Rapid City Planning Commission

Planned Development Project Report

Case # 15PD033, a Final Planned Development to allow ministorage units in General Commercial District

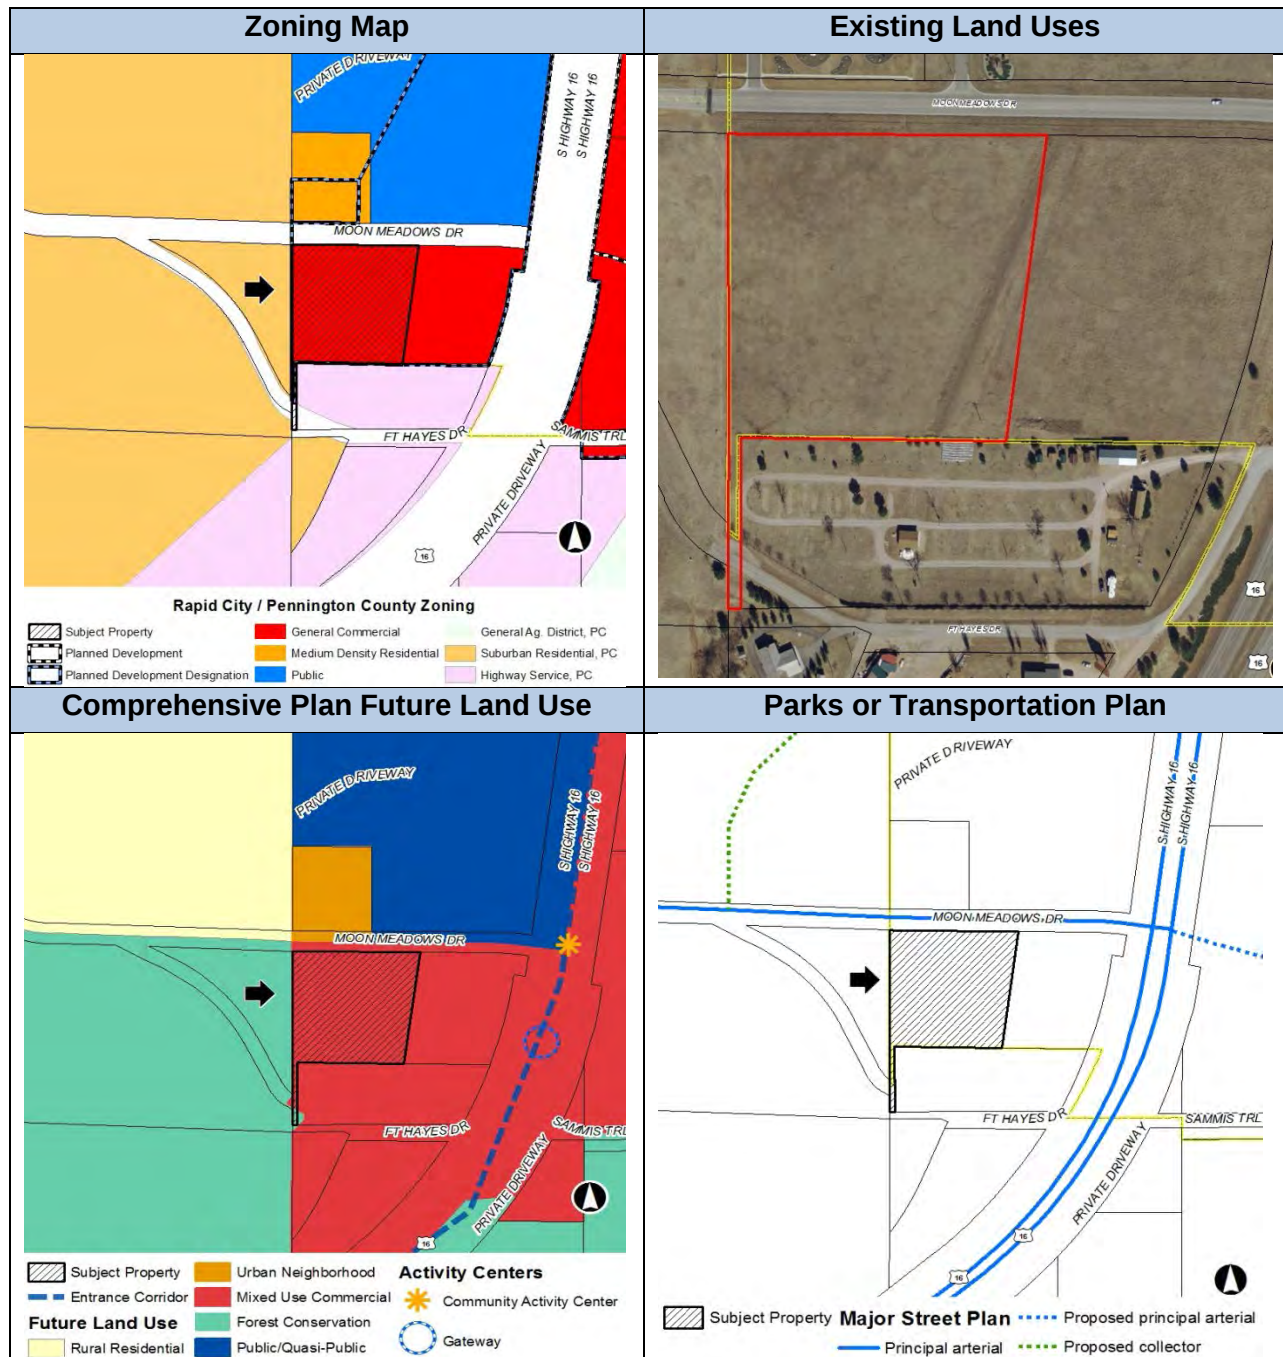
The applicant has submitted a request for a Final Planned Development Overlay to allow construction of ministorage units in a phased project located on property zoned General Commercial District. The submitted plans show that Phases 1 and 2 consist of 14 structures with a total of 96,200 square feet of storage space proposed. The structures will be built with steel construction materials and painted tan and green. Ministorage units are a conditional use in the General Commercial District, and require certain design criteria to be met. As such, the applicant has submitted this Final Planned Development Overlay to allow the ministorage units as a conditional use on the property and has requested the following Exceptions to the design criteria:

- An Exception to waive the requirement to provide an opaque screening fence, **and**;
- An Exception to **waive** the required building materials.
